ILLINOIS COMMERCE COMMISSION
TRANSPORTATION DIVISION / RAIL SAFETY SECTION

This letter has reference to the CSX Transportation Inc. plans with revisions dated September 15, 2008, Form 1 notice dated September 16, 2008, for proposed extension of gate arm lengths to previously approved plans under X-Resolution 12767 dated September 03, 2008 at US 6 (**AAR/DOT #608232Y, railroad milepost 14.13-RIM**) highway-rail grade crossing in Channahon, Will County, Illinois

Subject: Rockdale, Will County, IL: Installation of flashing lights, gates and circuitry at US 6, DOT 608232Y, MP BIF 46.30, OP# IL0245, T08-0122, X-12767

Form 1

AMOCO INDUSTRIAL LEAD
US-6 608232Y
TRACK AND SIGNAL PLAN
ROCKDALE, IL M.P. BIF-46.30

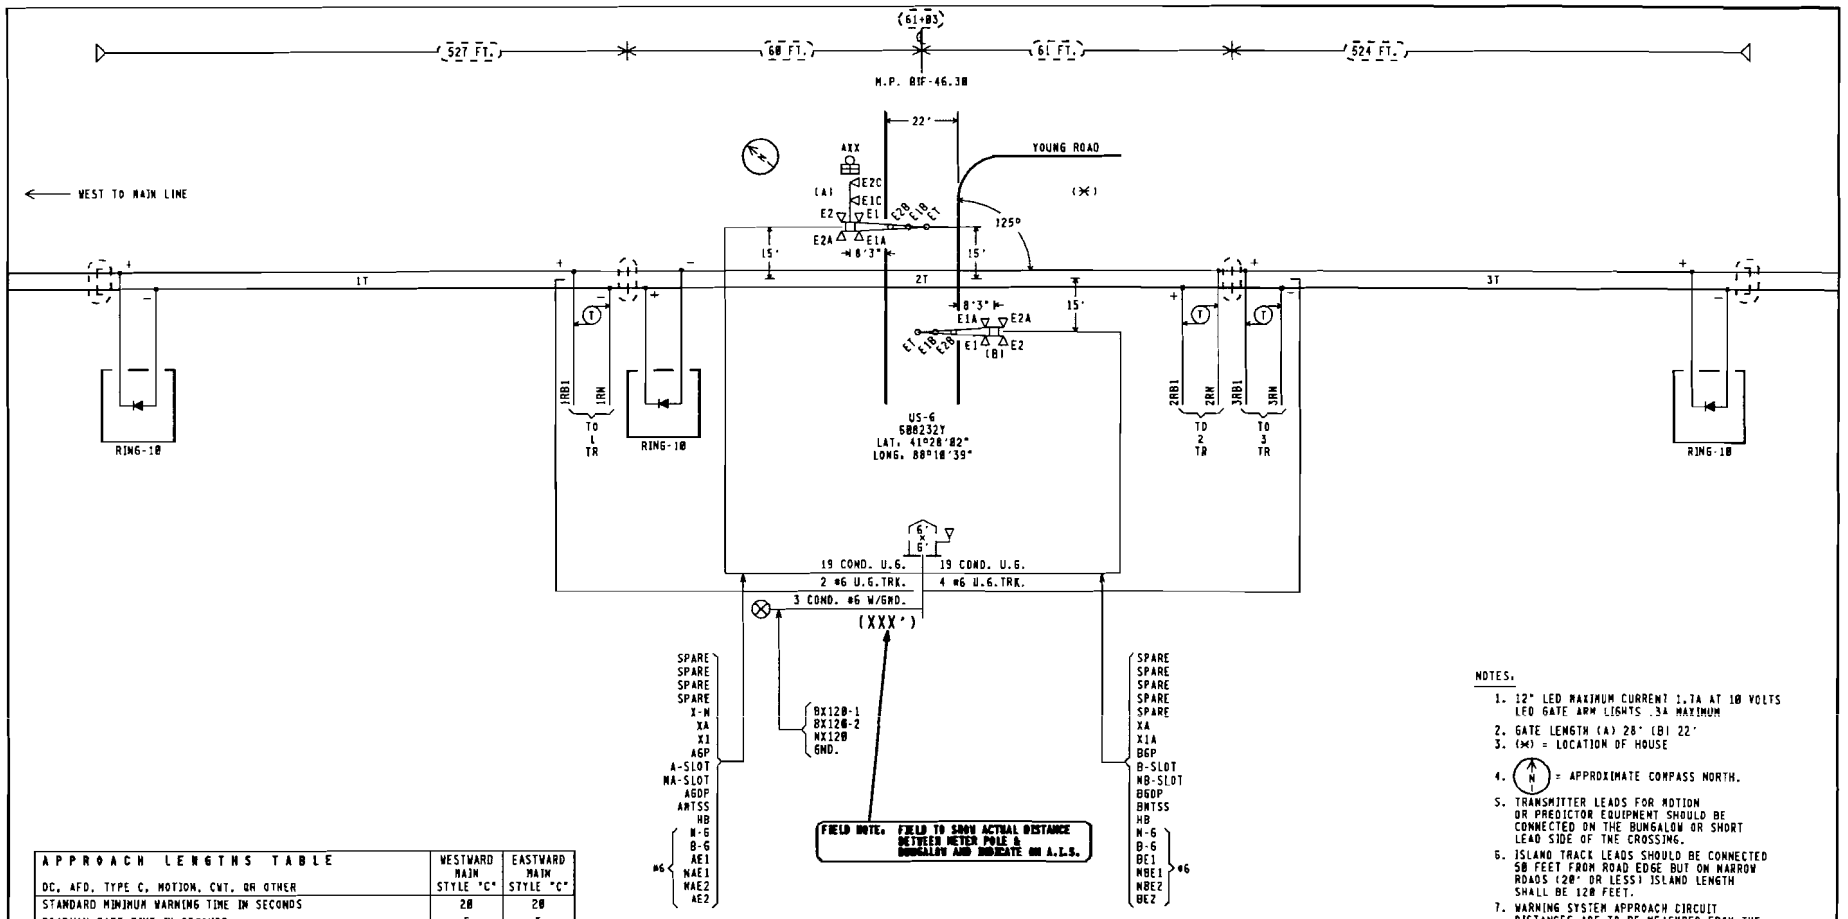
This office takes exception to the proposed modifications and therefore the Form 1 notice dated September 16, 2008 is not approved. The previously approved plans under X-Resolution 12767 dated September 03, 2008, without extending gate arms beyond the center of the roadway is still in effect.

Enclosed is a signed copy of the Form 1 for the subject project. CSX designed the gate arms at the standard length of 22' and 18'. Per conversation with Mr. Andy Rabadi at the Illinois Department of Transportation (IDOT) on Monday, September 15, 2008, the original request from IDOT was for the gate arms to be 28' and 22' respectively. This information is noted in exhibit A of the Agreement.

Gate Lengths have been changed to 28' and 22' per request by Andy Rabadi.
